STATE OF NORTH CAROLINA  
DEPARTMENT OF TRANSPORTATION

Subject: **Application for Permit Modifications for Section 404 Individual Permit and Section 401 Water Quality Certification** for the US 421/NC 87 (Sanford Bypass) from west of SR 1400 to west of US 1/15/501 in Lee County, Division 8. Federal Aid Project No. STPNHF-421(2), State Project No. 8.T540402, WBS Element No. 34431.1.1, TIP No. R-2417AA.

NCDOT has made some modifications to the permit based on some incidents during construction. Below is a description of the changes to three permit sites. Drawings of the changes are attached.

# Site #6

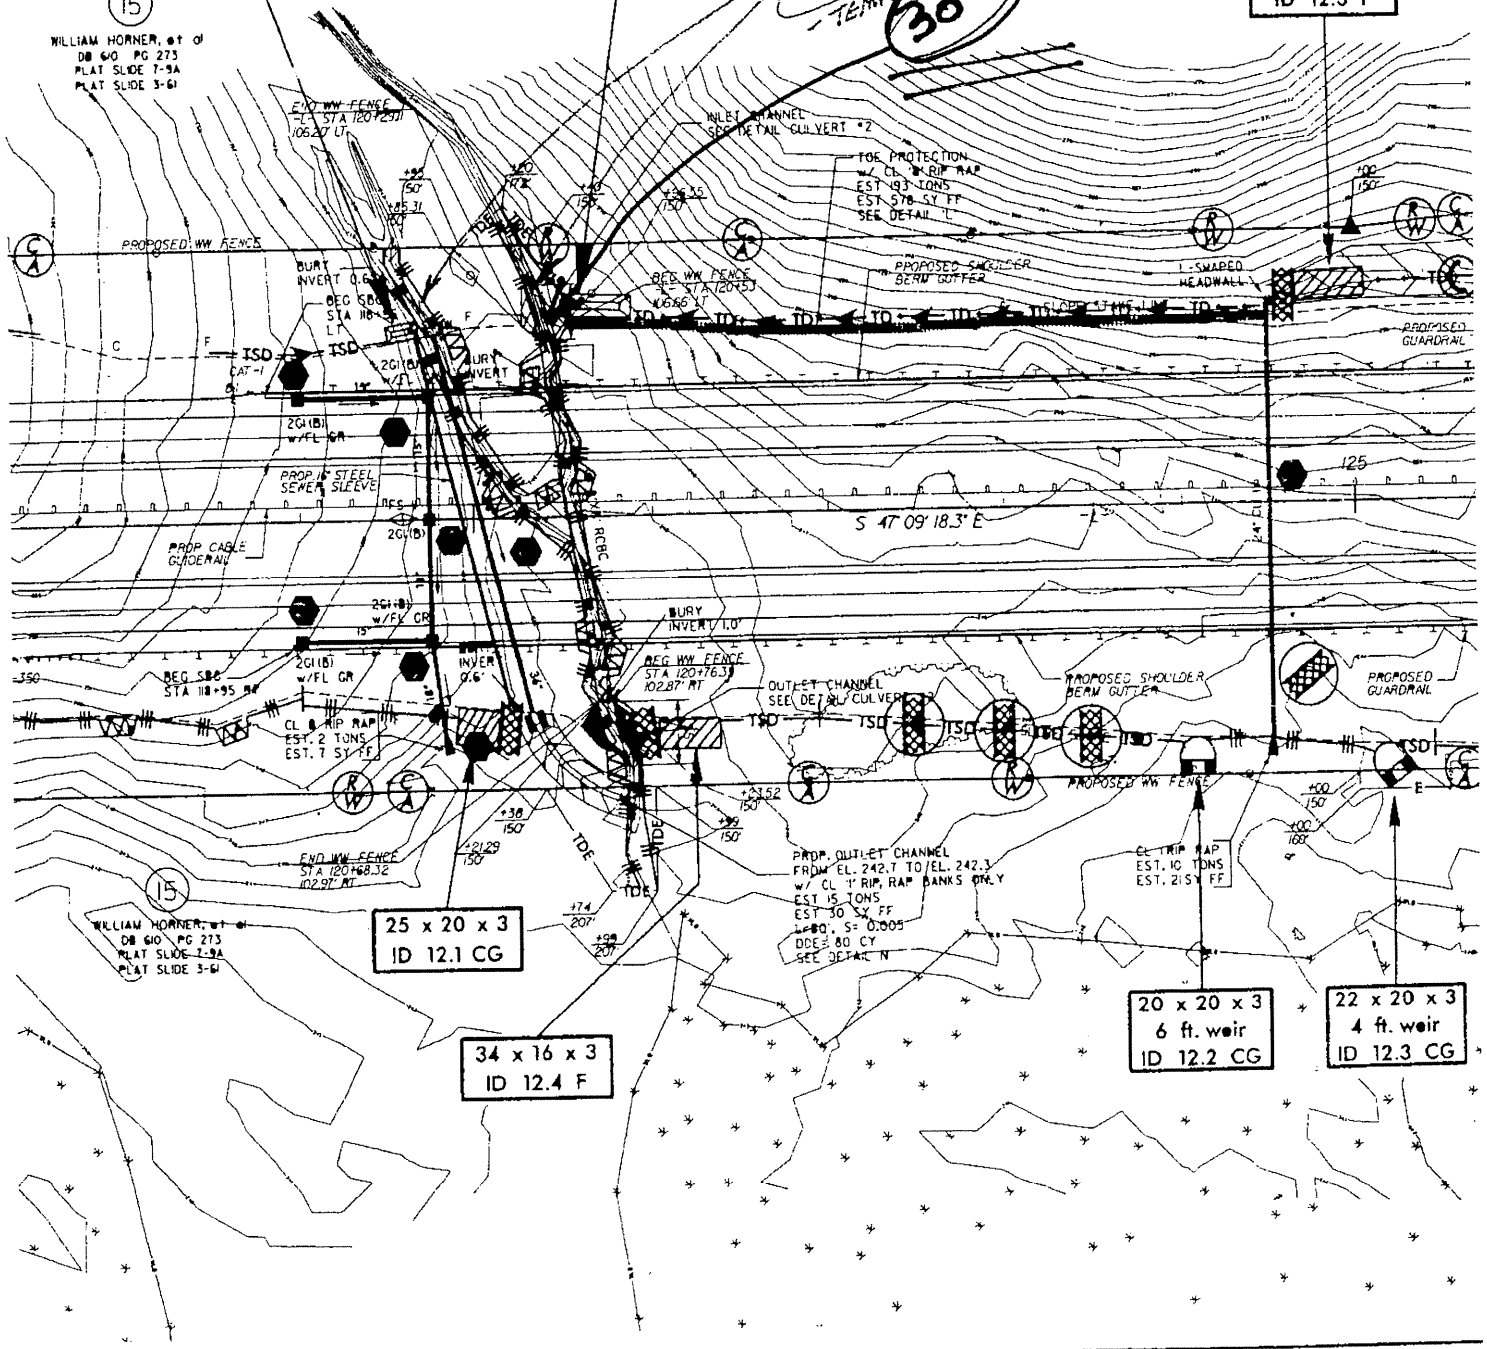
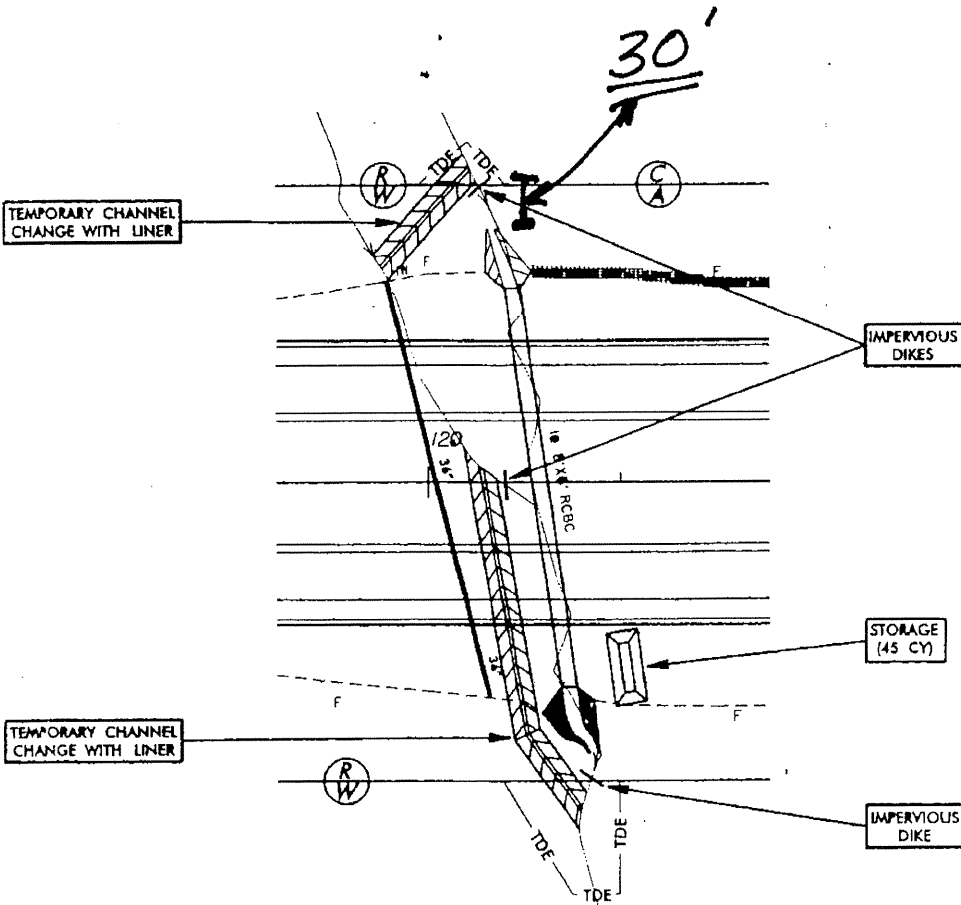
### **Site 6 Station 120+20(LT) and 120+57(LT/RT)**

An approved temporary stream crossing plan drawing was included in the construction plans (Sheet EC-2D). This plan is suitable for a crossing that does not require that flow be maintained by simply removing the pipe. This plan was not followed by the contractor at this location. Instead, an earthen dike without a fabric liner was placed in the dewatered stream channel between the diversion device and the upstream end of the newly constructed culvert by the contractor. This area was used as a crossing point to move equipment around the culvert during construction. We acknowledge that the crossing was improperly installed and has impacted the existing stream channel.

The actions above will be an additional 30 feet of temporary stream impacts. The earthen dike will be removed and the channel will be restored to its original contours, re-vegetated, and allowed to stabilize before the stream is turned into the new culvert.

# Site #9

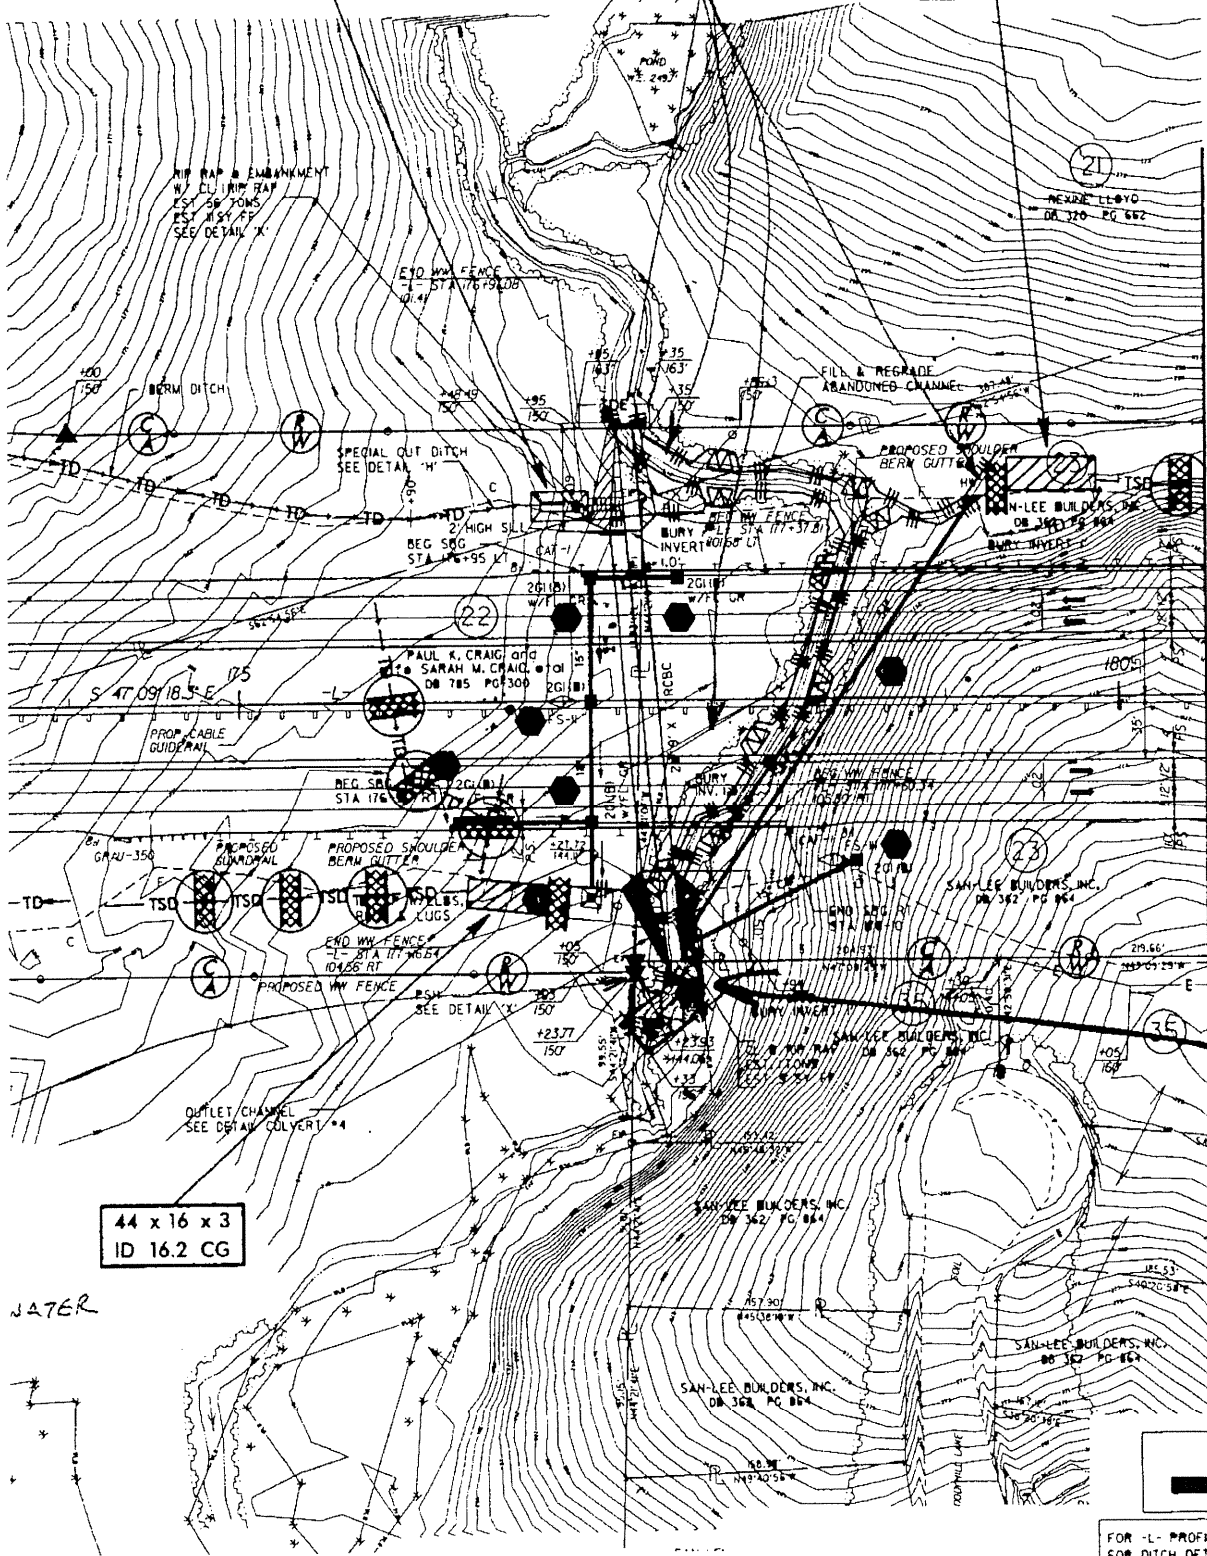
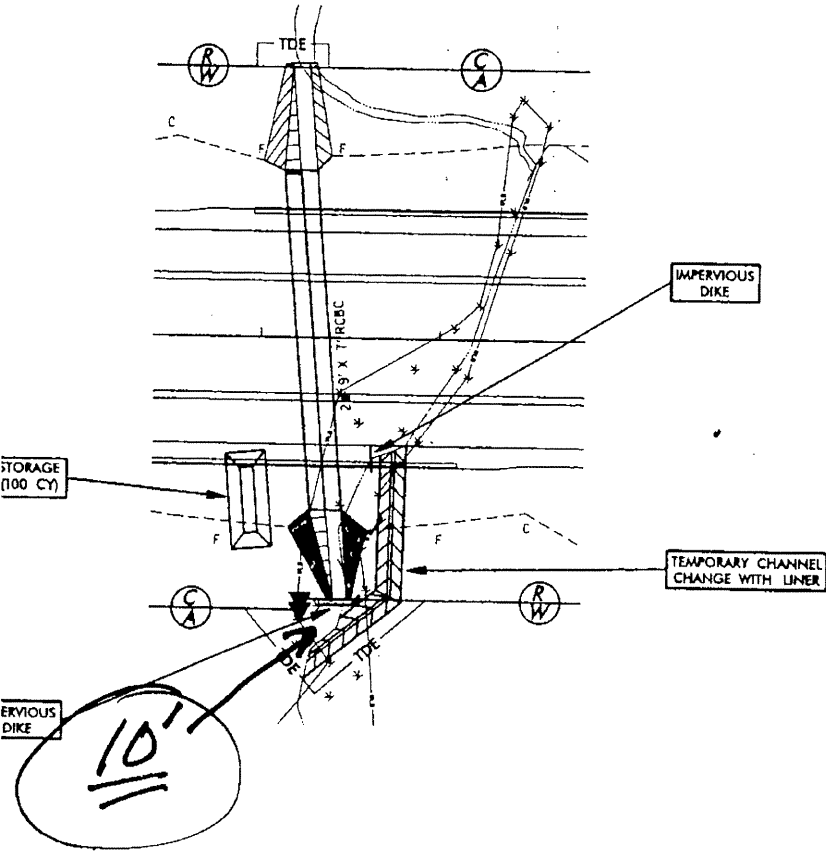
### **Site 9 Station 178+82(RT)**

Approximately 10 feet of the original stream channel was filled with an earthen dike by the contractor as a means to move his equipment around the culvert structure.

The actions above will be an additional 10 feet of temporary stream impacts. The earthen dike will be removed and the channel will be restored to its original contours, re-vegetated, and allowed to stabilize before the stream is turned into the new culvert.
